#### **Planning Commission Staff Report**

**Project Type:** Site Development Plan

Meeting Date: December 12, 2016

**Description:** The Wedge McGrath Plaza (Energy Express): A Site Development Plan, Landscape

Figure 4: Easternmost access point as approved via Ordinance 2820

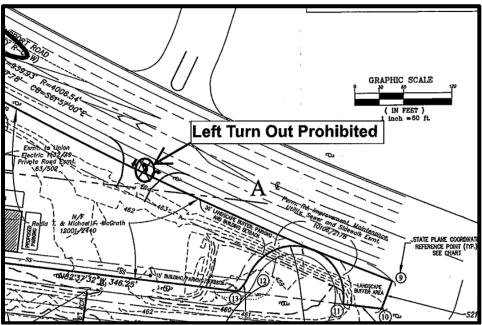
Two access points are provided along Chesterfield Airport Road and two along Old Olive Street Road. However, the configuration of the easternmost access point on Chesterfield Airport Road does not conform to the approved site specific Ordinance 2820 and associated Preliminary Plan. Specifically, the Site Development Plan proposes a left turn movement into the easternmost access of the development which is specifically prohibited, as shown in the following excerpts from Ordinance 2820 and the Preliminary Plan:

- 1. Access to the development, except for the access to Out Lot A, shall be as shown on the Preliminary Plan, and adequate sight distance shall be provided, as directed by the City of Chesterfield, the Missouri Department of Transportation and St. Louis County Department of Highways and Traffic, as applicable.
  - a. The access to Out Lot A shall be as directed by the City of Chesterfield.
  - b. Left turn movements out of the development, at the easternmost access point along Chesterfield Airport Road, shall be prohibited.

The issue of access was discussed at length during the zoning process for this development. Throughout the Site Development Plan review process, Staff has asserted that the access as shown on the Site Development Plan does not comply with the Ordinance; however, the applicant has declined to revise the Plan. The Applicant is requesting approval of the Plan as submitted (see attached letter). Additionally, on August 26, 2016 the City received a letter from St. Louis County stating that they were requiring the left turn movement out of easternmost access to Chesterfield Airport Road. As City Staff makes our recommendations based upon adherence to the City Code and the planned district ordinance, Staff is recommending that this access be restricted so that no left turn is permitted, as required in Ordinance.

- 1. That the easternmost access point comply with Attachment B of Ordinance 2820; and
- 2. That street lights be provided along Chesterfield Airport Road and Relocated Olive Street Road with a note on the Site Development Plan requiring installation and maintenance be the responsibility of the Developer; and
- 3. That if the architectural elevations are approved as submitted by the Applicant with the new archways, said archways be reduced in height.

DRIVE-THRU & CAR WASH SIGNAGE ELEMENT N.C.S.

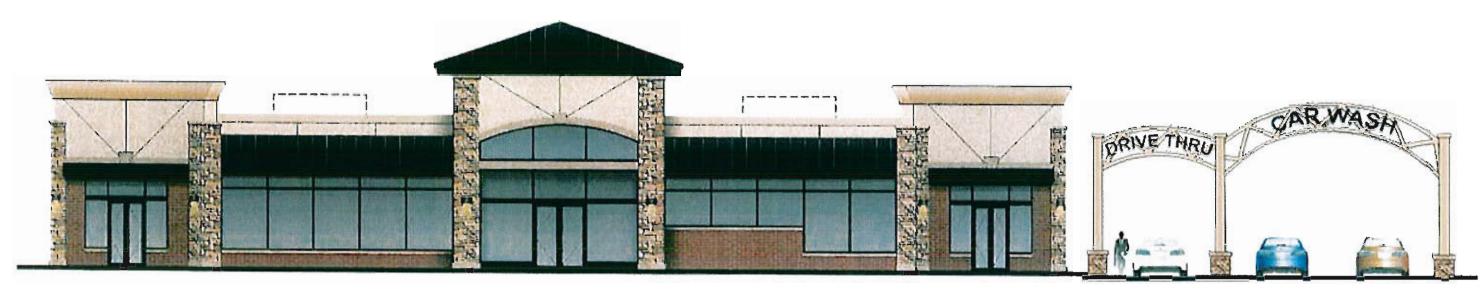
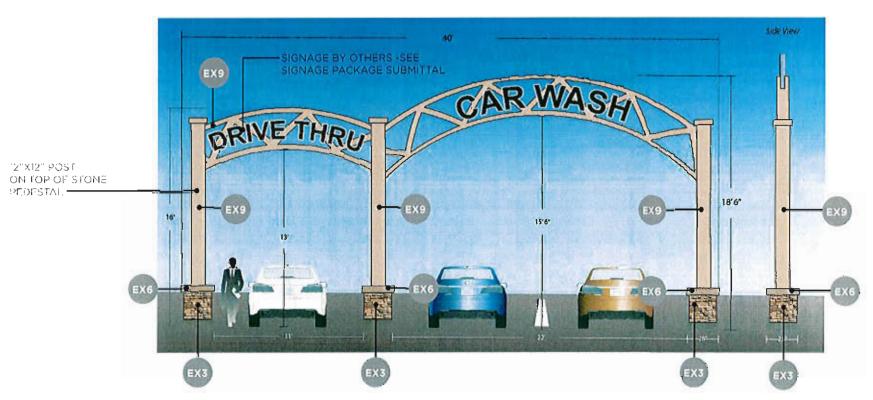
The applicant is proposing to construct an architectural archway feature at the entrance to the car wash and restaurant drive-thru lane entrances adjacent to the c-store building. This archway, shown in the images below, was not included in the ARB submittal. Based on this, Staff is requesting Planning Commission input of the appropriateness of this feature given its prominent location, size, and visibility from Chesterfield Airport Road. The proposed archway is 18'6" at the tallest point. Note that although signage is shown, signage is reviewed as a separate process. In this case, the applicant has submitted a Sign Package that is requesting lit signage on the archway. As part of that review, Staff has provided comments pertaining to the prominence and visibility of the signage from Chesterfield Airport Road and will make recommendations pertaining to signage based on the Applicant's response to these comments. Once Staff review of the Sign Package request has concluded, the Sign Package will be placed on a Planning Commission agenda for review.

Regarding the archway as architectural element alone, without consideration to the signage request, Staff would note that it is substantially taller than required to provide the necessary clearance for vehicles to enter the drive thru lanes. Based on this, Staff recommends that the Planning Commission consider reducing the height so it is more integrated with the adjacent building.

ATM CANOPY - SIDE VIEW

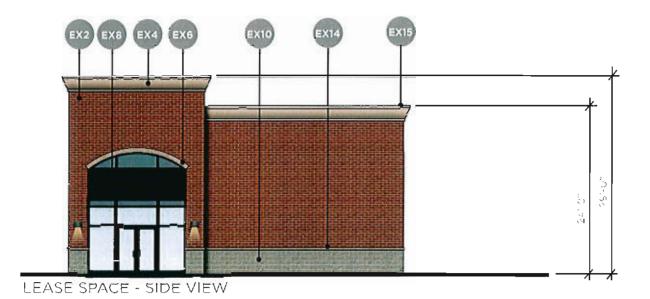
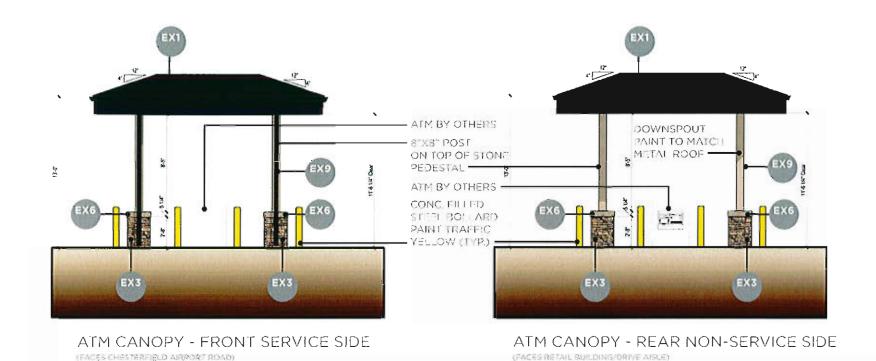
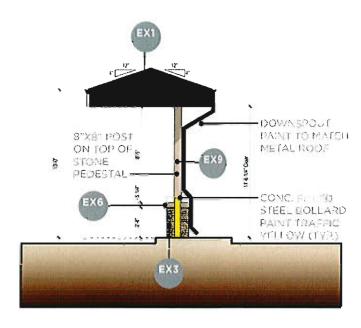
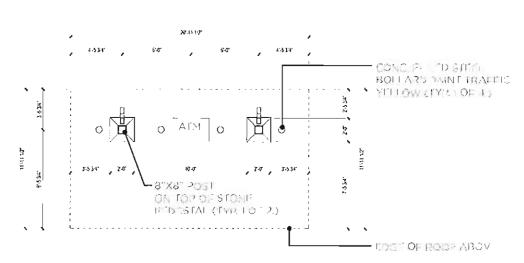
More detail should be provided for the appearance of the ATM area and consideration be made to integrate its design with the proposed architecture of the buildings and/or use landscaping to screen.

In response to this recommendation, the applicant has provided a rendering and Architectural Elevations for the proposed ATM in order to ensure that the design is integrated with the proposed buildings. Note that the island containing the ATM will be planted with shrubs, as shown in the Landscape Plan.
